SUBJECT: Forwards response to NRC 801215 questions re SEP Topic IV-2, reactivity control sys. Design features which limit reactivity insertion rates & rod malfunctions from single failure described.

Subject: SEP Topic IV-2, Reactivity Control Systems
R. E. Ginna Nuclear Power Plant
Docket No. 50-244

Response to SEP Topic IV-2 Questions

Figure 4-31. Power Cabinet, Schematic Diagram 1051E05
(Sheet 2 of 14)

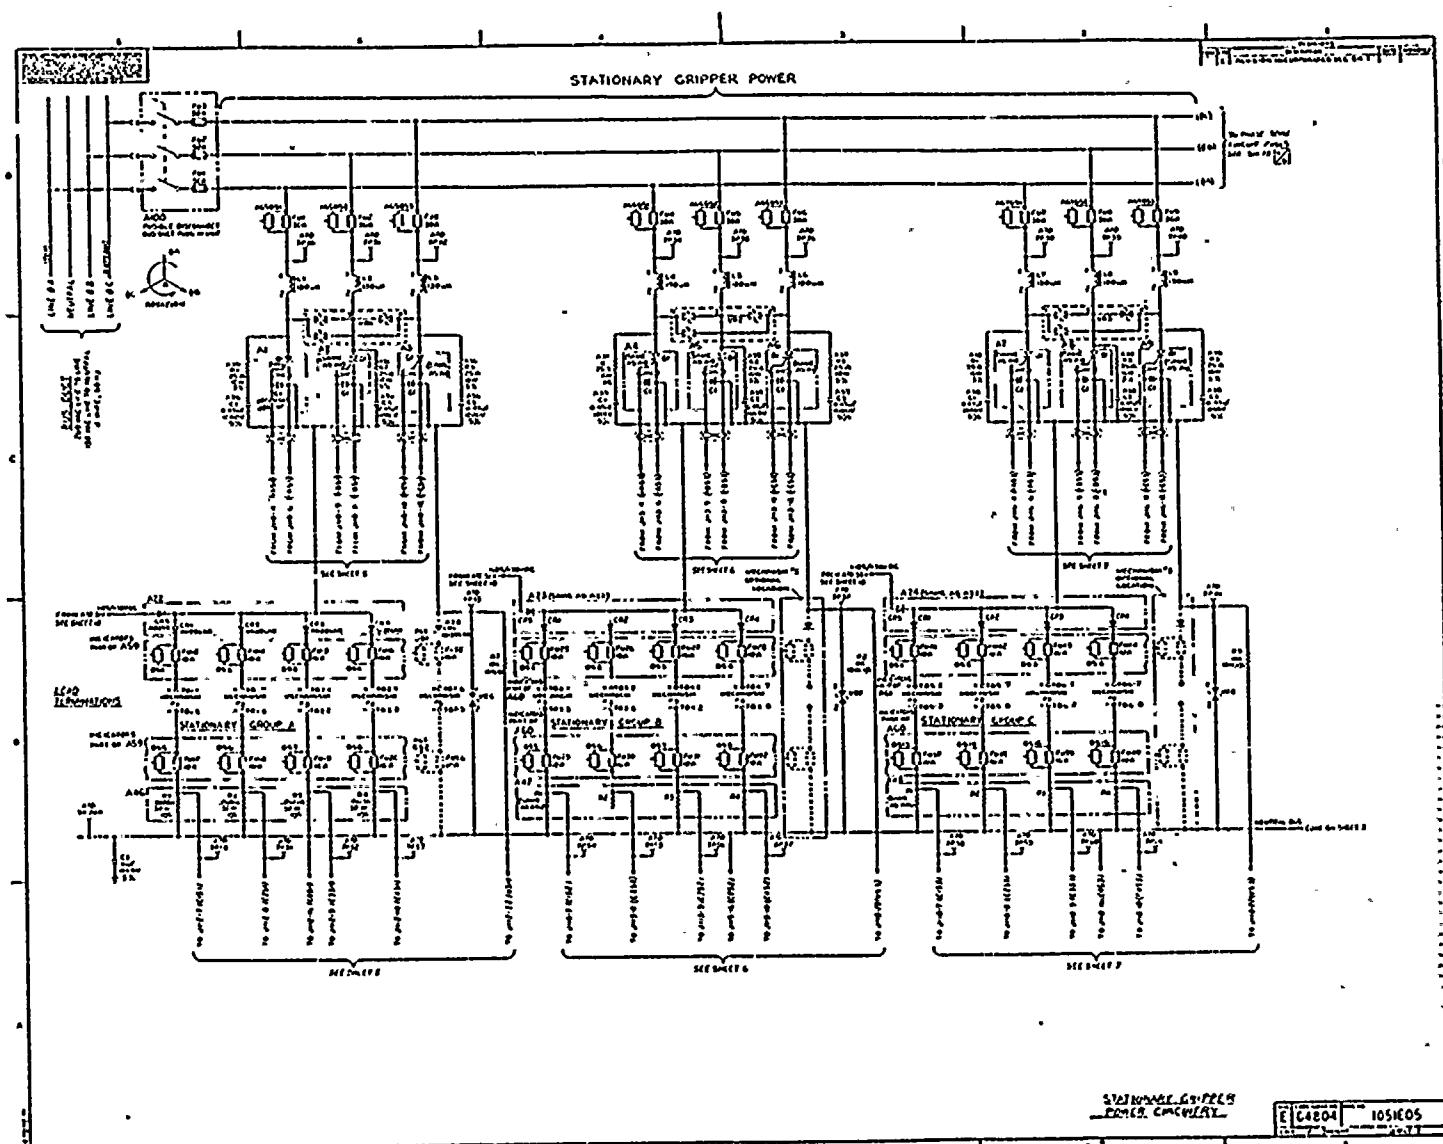
1. Any card not in place - each card has an interlock circuit associated with the Urgent Alarm.
2. An abnormal change in phase or current returning from the coils (Ripple detector 1051E05 sheet 2 & 10).
3. Coil current remaining saturated too long (E Sat. Detector 1051E05 sh. 2).
4. Firing circuit error (1051E05 sh. 11 & 12).
5. Multiplexing error (1051E05 sh. 12).
6. Logic Error (1051E05 sh. 12).

Figure 4-31. Power Cabinet, Schematic Diagram 1051E05
(Sheet 9 of 14)

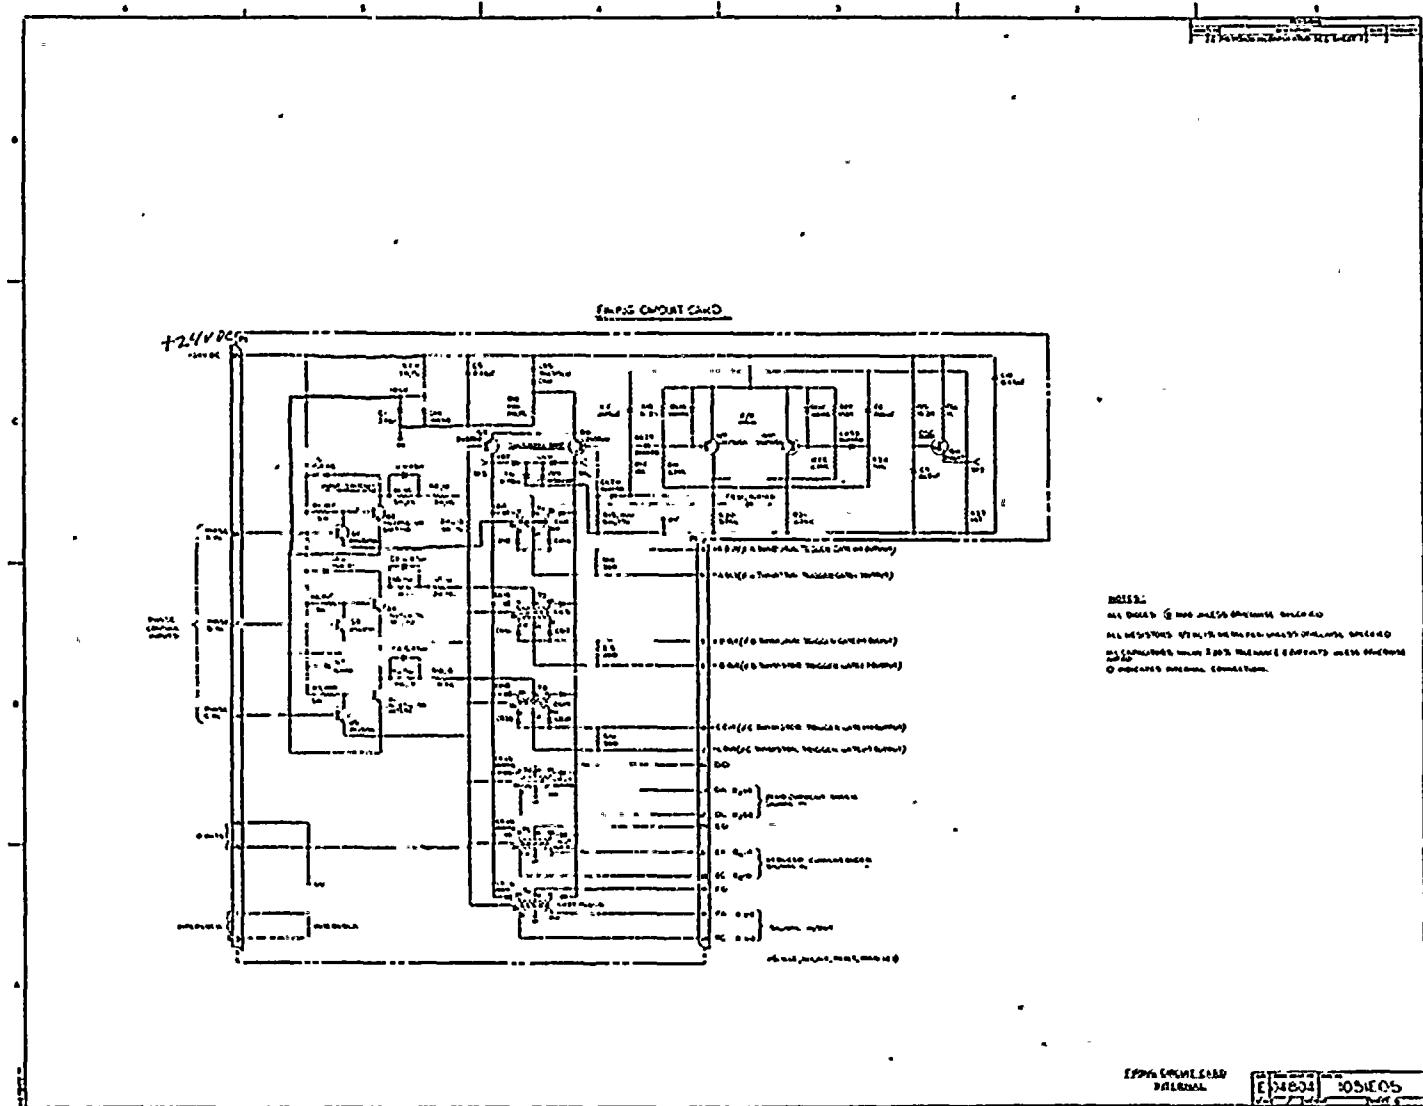
1. Signal AL-1 is generated and commands reduced power to the Stationary and Movable Gripper Regulation Cards (1051E05 sh. 9 & 12).
2. Signal AL-3 is generated and commands zero current on Lift Regulator Card (1051E05 sh. 10 & 12).

Figure 4-68. Logic Cabinet, Logic Flow, Maximum System 6056D01 (Sheet 2 of 15)

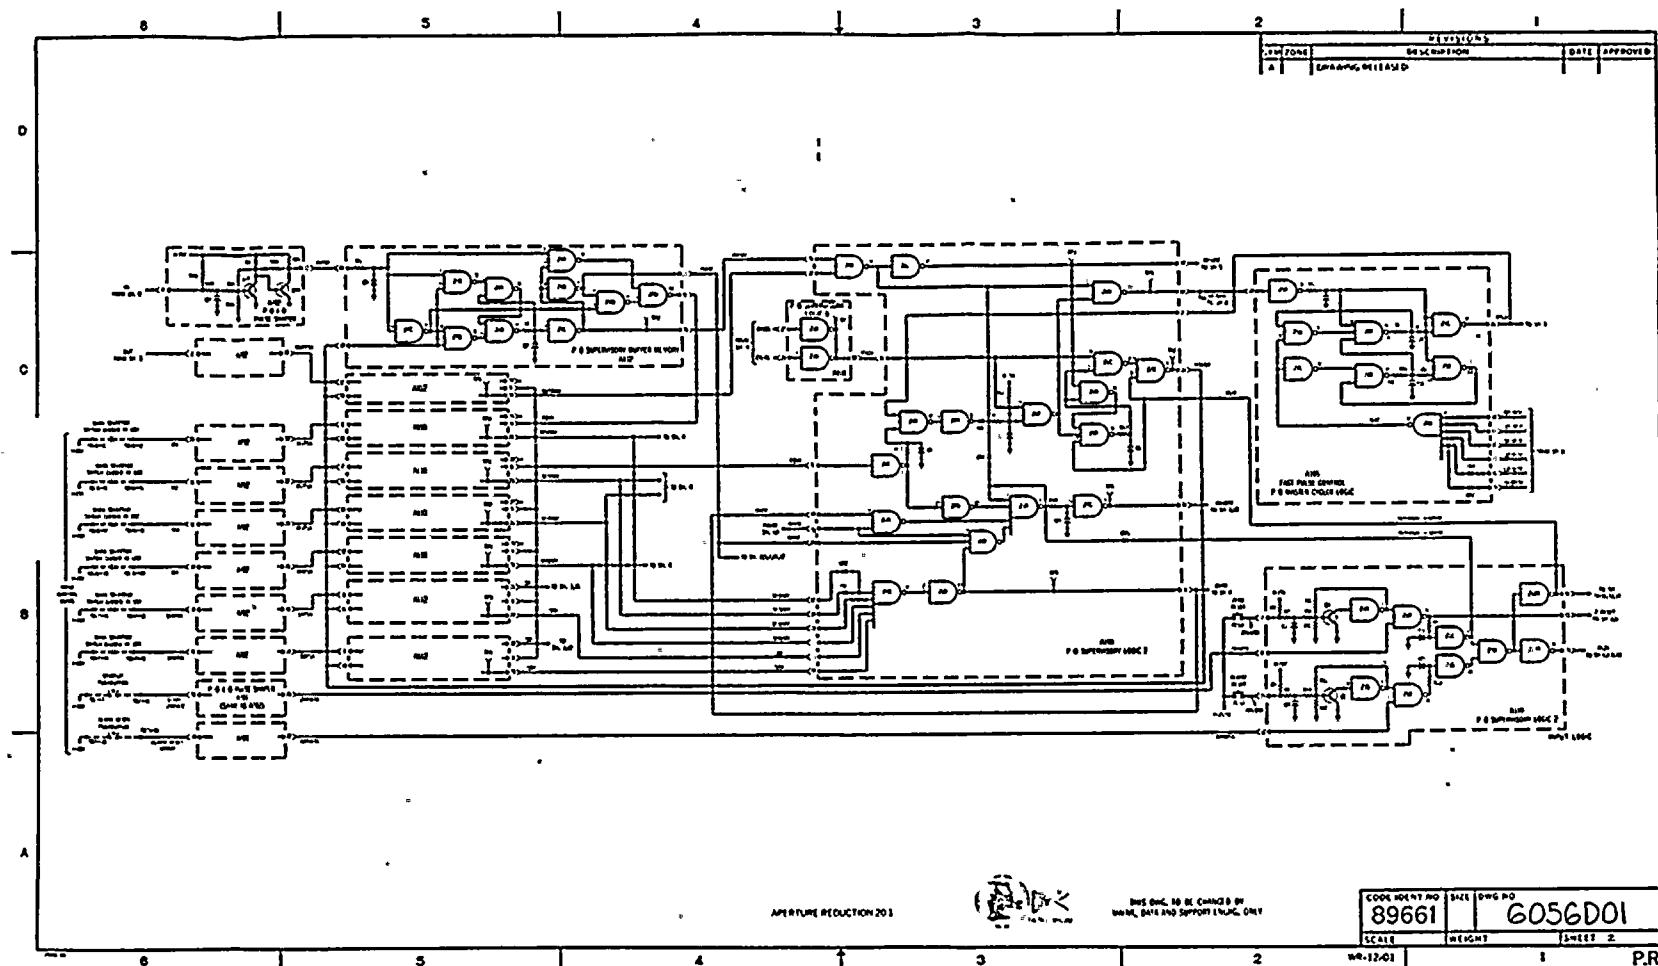
Rod positioning is controlled by the bank overlap unit (6056D01 sh. 2 & 4). This unit keeps track of rods that move and rods to be moved sending a signal to the power cabinets. Thumb wheel switches with two diodes per switch per digit control bank overlap.

Figure 4-68. Logic Cabinet, Logic Flow, Maximum System 6056D01 (Sheet 4 of 15)

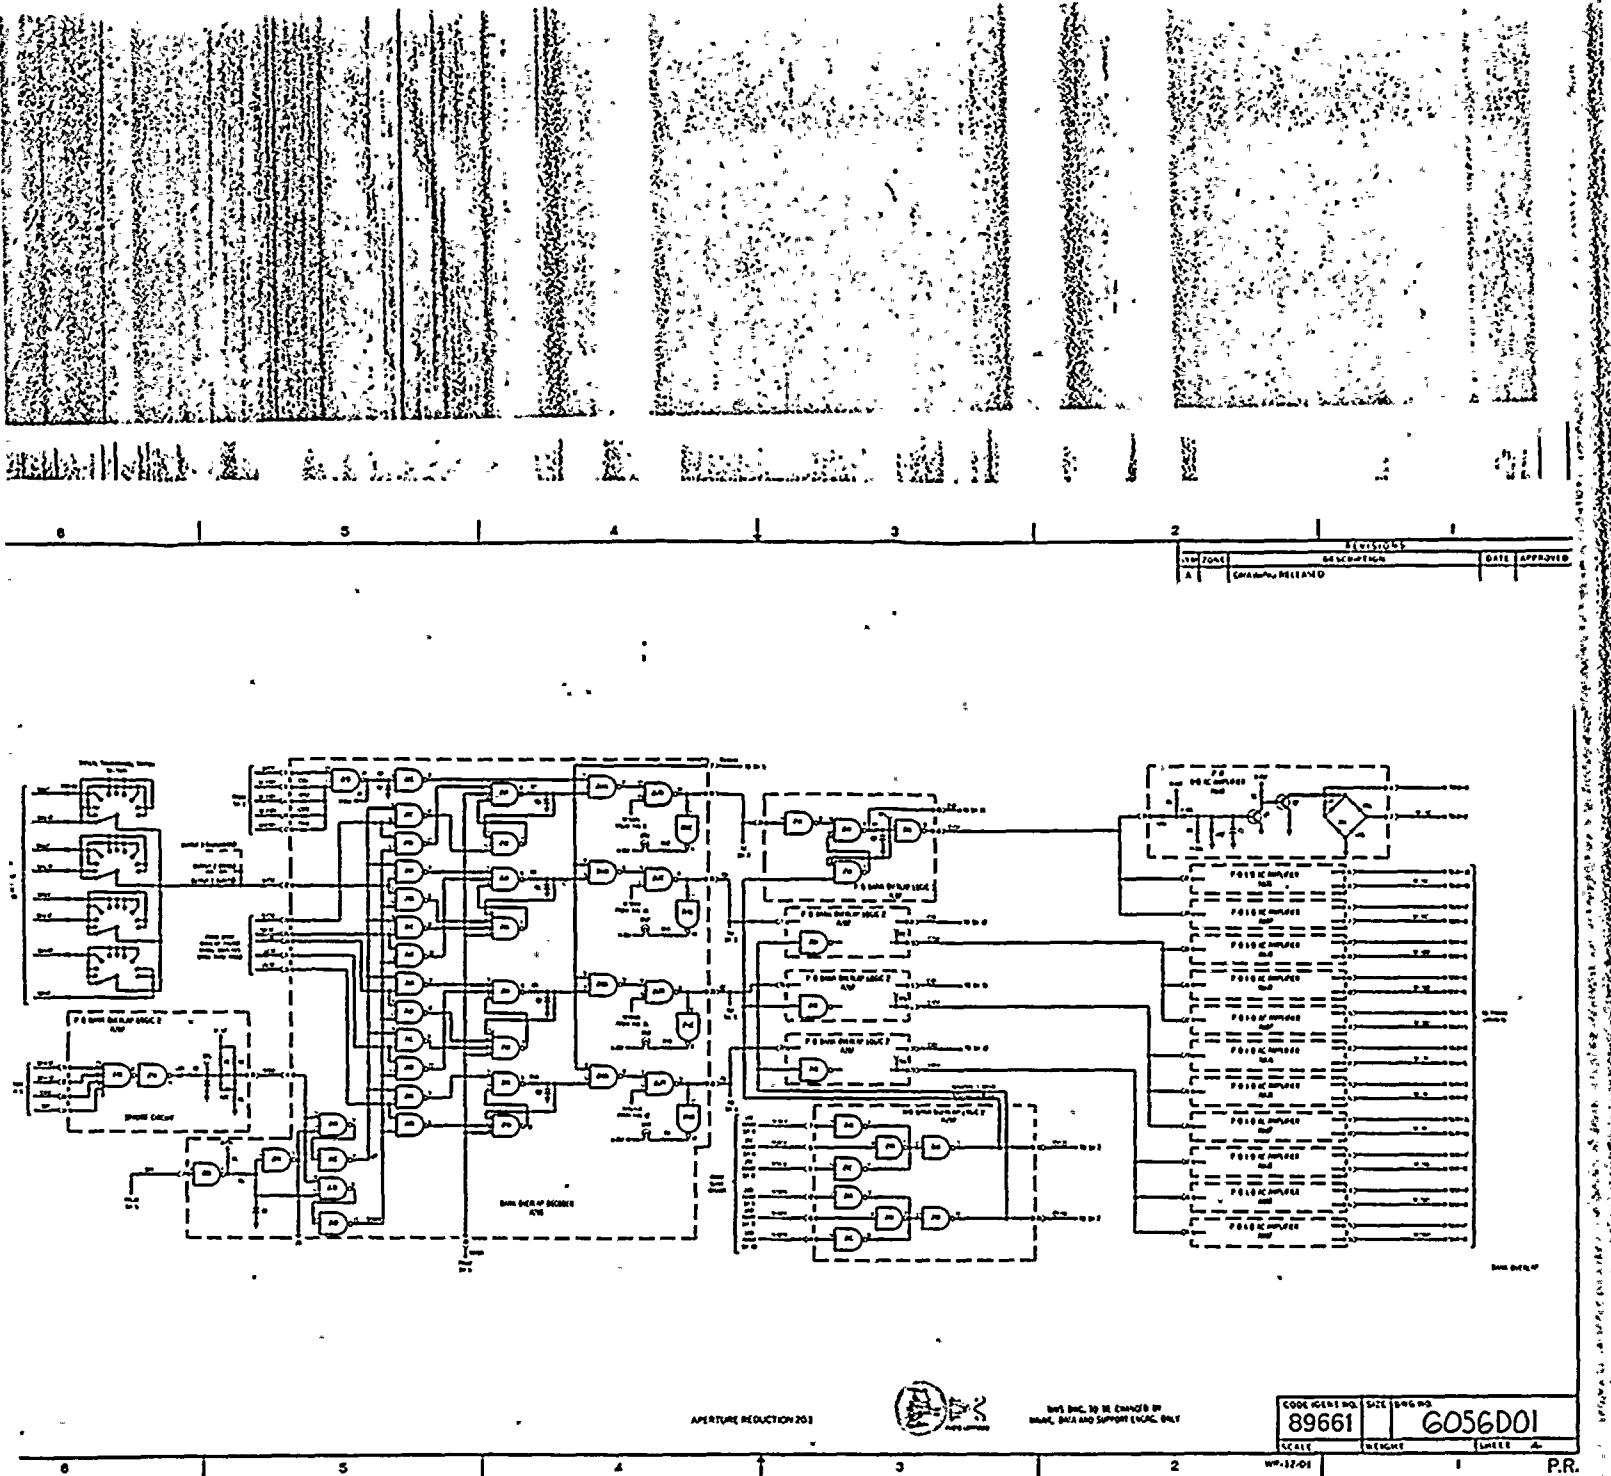
Another feature which limits the reactivity insertion rate is the manner by which rod speed is controlled. A buffer memory accepts a command go signal. Another go signal is inhibited until a slave cycler finishes. (6056D01 sh. 4 and Figure 1-6).
